# Ottershaw East Planning Application

Objections

## Policy SL12: Housing Allocation at Ottershaw East, Ottershaw

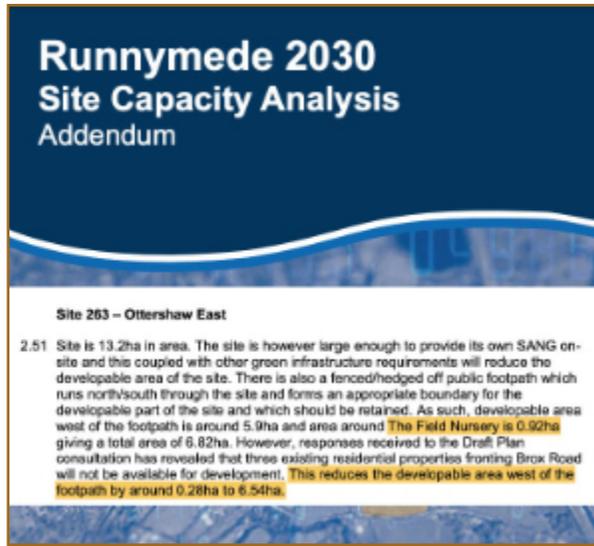
SL12 shows that the developable area is west of the footpath. The area known as the Field Nursery did not come forward.

From Google mapping the remaining area is 5.3ha

According to the SCA which informed the LP, the FN is 0.92ha  
Therefore, developable area is  $6.54 - 0.92 = \underline{5.62ha}$   
Not 6.7ha as stated by Vistry.

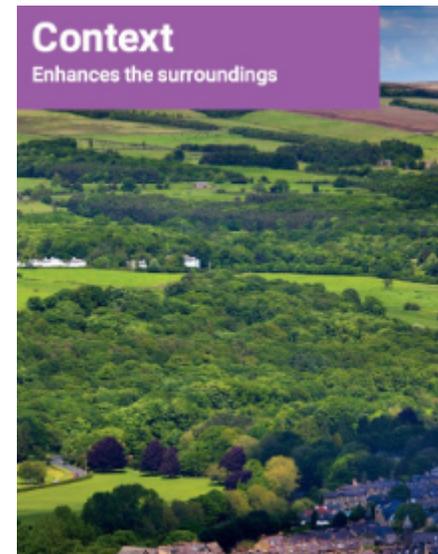
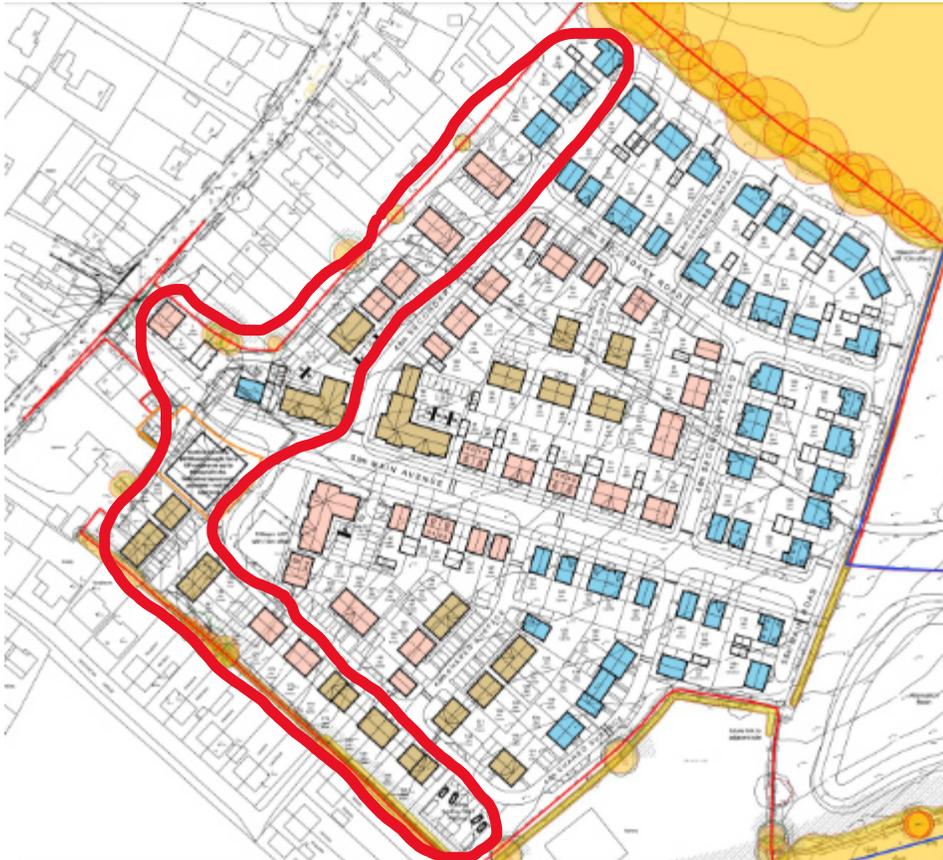
Density doubles against existing housing on the SW and NW border

Poor contextual relationships

Note denser housing is adjacent to existing properties but not evident within the main site

Taylor Wimpey Site Green Lane. Note Green buffer around the site edges with existing dwellings

Note comparison with Taylor Wimpey site at Green Lane  
Bordering properties integrate well against the development and reflect the adjacent built form

## THE RELATIONSHIP SW CORNER

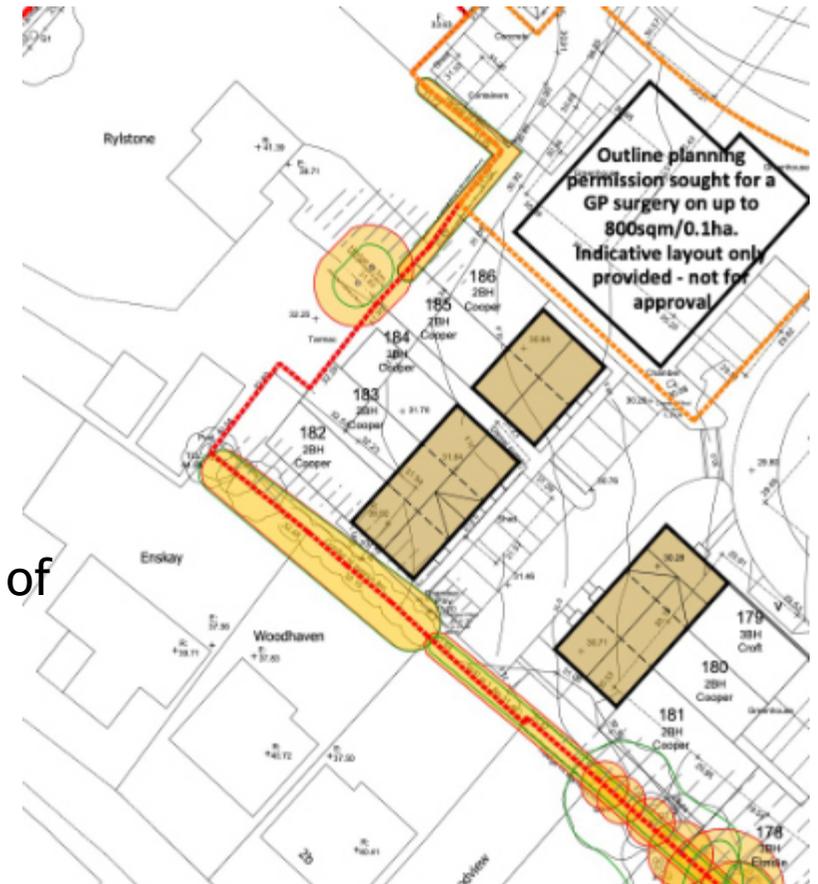
Detached houses juxtaposed with an overly dense arrangement of terraced housing.

5 properties plus GP surgery backs onto Rylance

Out of context and does not relate well.

Contrived landscaping is not a solution to poor design.

- Runnymede design policies specify a back-to-back arrangement which is ignored here.
- Large parking courts backing on to detached housing is out of context, does not relate well or integrate
- Security issues providing easy access to the rear of existing properties, privacy and nuisance from car turning and headlights
- Woodview suffers loss of outlook as large gable end eclipses garden.
- Minimum separation distance not complied with (should be 17M)
- Suffers overshadowing and visual dominance
- Blank gable ends obscuring outlook for existing properties contrary to best practice

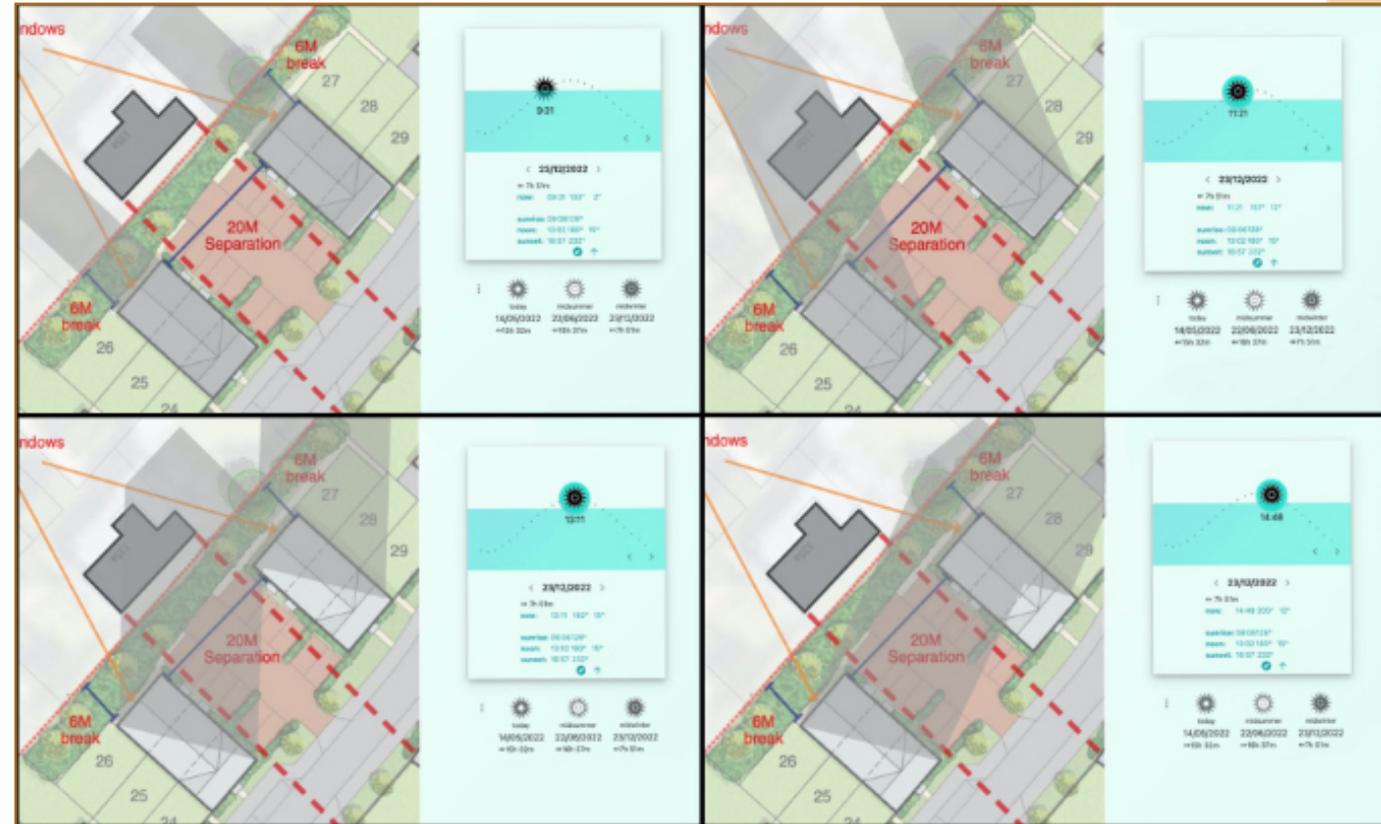
- Back to gable end distances range from 12–20M
- Orientation maximises solar gain and reduces overshadowing
- Back-to-back layout evident
- Parking courts not placed behind gardens

Noted to be a vulnerable property. And yet:

- Separation distance is a mere 8M compared with 12–20M within the development
- The 2 terraced blocks are placed to cause maximum overshadowing as daylight is derived from a SE direction.
- Overlooking occurs from close angular distances
- Proximity causes loss of outlook.
- The large size and proximity of these housing blocks causes intrusion and visual dominance.
- The usual rule of thumb for oblique orientation is to reduce minimum B2B distance by 25% therefore should be 17M not 8M
- 12 bay open parking court provides easy access to rear of property. Full beam headlights directed straight into living rooms at night.
- Back-to-back requirement of Runnymede design SPD ignored
- Blank gable ends eclipse and box in the gardens which are set out to the side

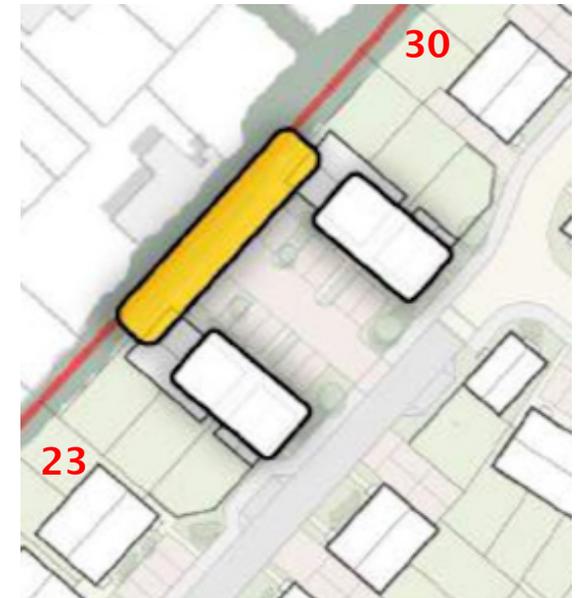
Pre-app discussion on 11/11/21 discussed arrangement where new housing is aligned with rear building line of plots 23 and 30 but this has been ignored in the final layout

The terraces are 12% higher in ridge height than 135A presenting increased bulk and mass

Although it is not a rear extension of an adjacent property, the proximity of the terraces and their height and bulk, to the rear elevation of 135A is sufficient as to have the same effect.

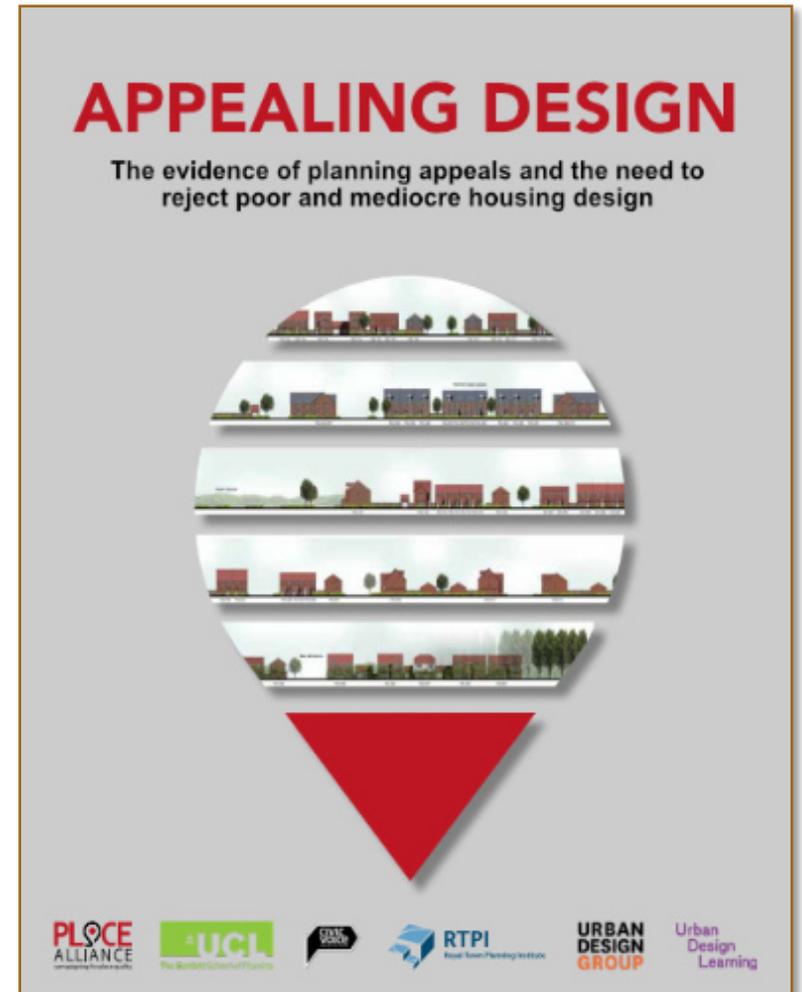
The style of housing is almost identical to those at all its sites across the country like this one in Mindenhurst

- Little variety
- No landmark buildings
- No placemaking, not distinctive
- Little distinction between so called "character areas"
- Identikit housing estate
- Enables bulk buying of materials nationally for all sites
